# LOS ALTOS HILLVIEW PARK & COMMUNITY CENTER

10/25/2014  
ALA Community Charette

## Design Team Concepts and Feedback

## PUBLIC REVIEW and INPUT

### Creating a COMMUNITY FEEL

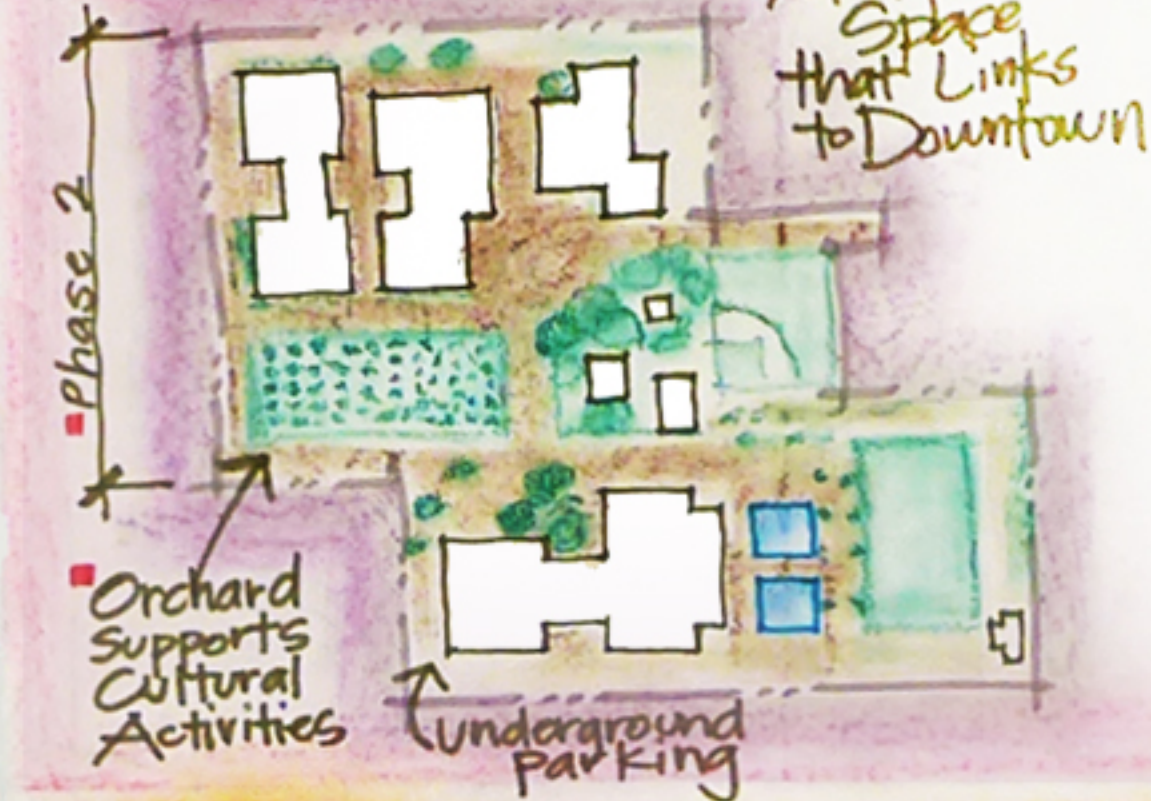
- Solar Canopies @ Parking Some ask: Eliminate? + Parking Because of \$
- Pool is in shade-like trees around
- Strong connection @ Edith
- Amphitheater near Theater
- Turn Parking Structure 90° + push towards Hillview Buildings
- Keep Trees away from Hillview and away from Pool as much as possible.
- Swim Center: Part of Intergenerational Community Center
- Reduce road cuts and Screen 2-story building masses.

- ▶ Integrate Pool - OPEN vs ENCLOSED
- ▶ Lockers should be better integrated
- ▶ Neutral House Parking + Gazebos - A mini campus
- ▶ Underground Parking under field.
- ▶ Vehicular Access at Perimeter Favored
- ▶ Move Police off Site
- ▶ Library: 2-stories more appropriate
- ▶ Reach out to Foundations and Non-Profits... an ENDOWED FLOOR? (Build Relationships!)
- ▶ Sun and Water. Use Natural Resources
- ▶ Hillview Experience: A Natural Street scope
- ▶ Berms. Preserve Residential Feel + Mitigate Acoustics

### The HERITAGE SCHEME Plan

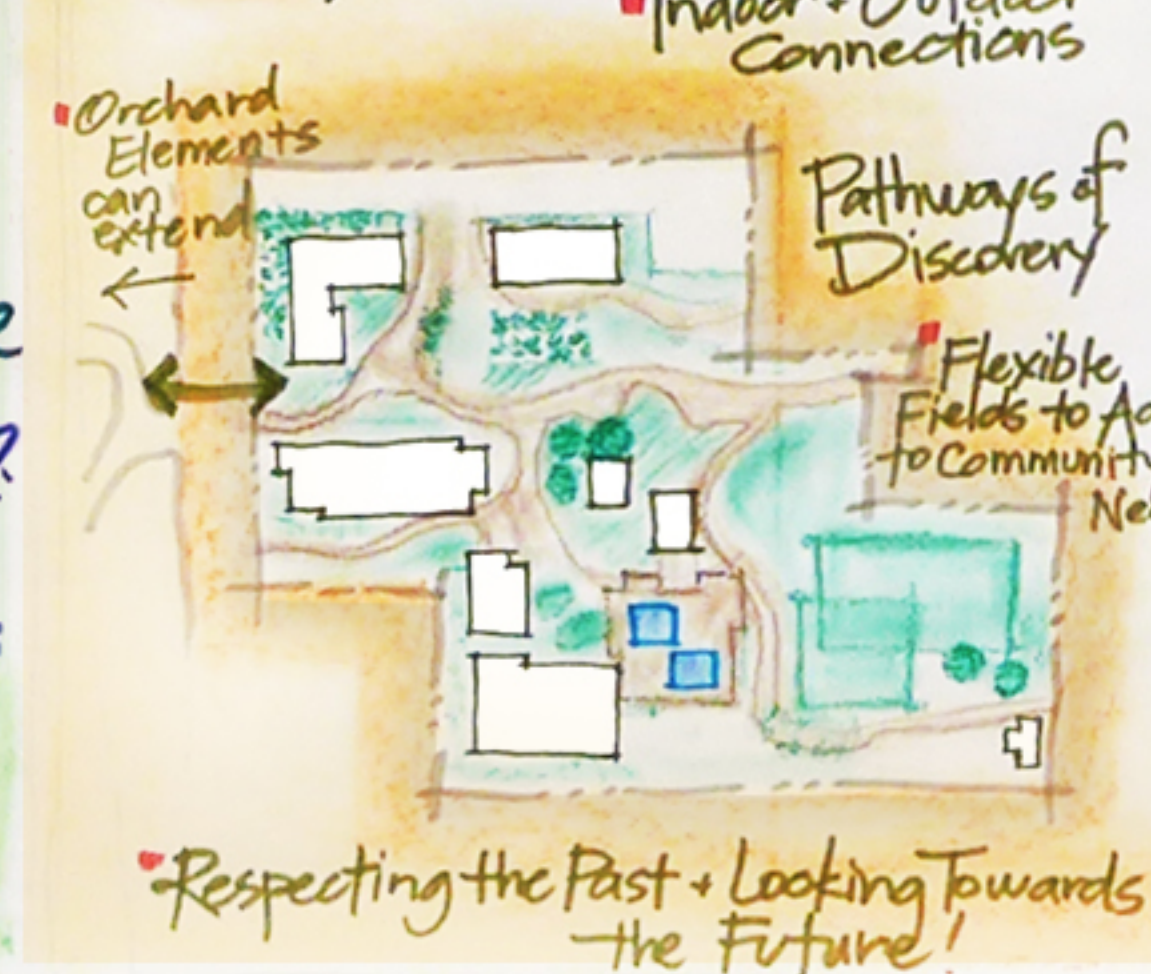
- Way too much Orchard! Some Love it!
- Love multiple ways thru site
- Relocate Police Station closer to San Antonio.
- Grand Entrance
- Pool noise may affect neighbors also love it
- Pedestrian Connections are best when located furthest South Also Connect to Downtown
- Reconsider need to increase size of community center due to slow growth.

- Maintaining 1/2 Acre of Orchard
- Love San Antonio Solution
- Extend Community to shield Pool
- Add water features Wildlife Friendly
- Study moving Police facilities off site.
- Possible Round About
- Love Intergenerational Possibilities of Different Uses.
- Rainwater Harvesting
- Permeable Pavers
- Expand Neutral House features
- Right-Size Fields
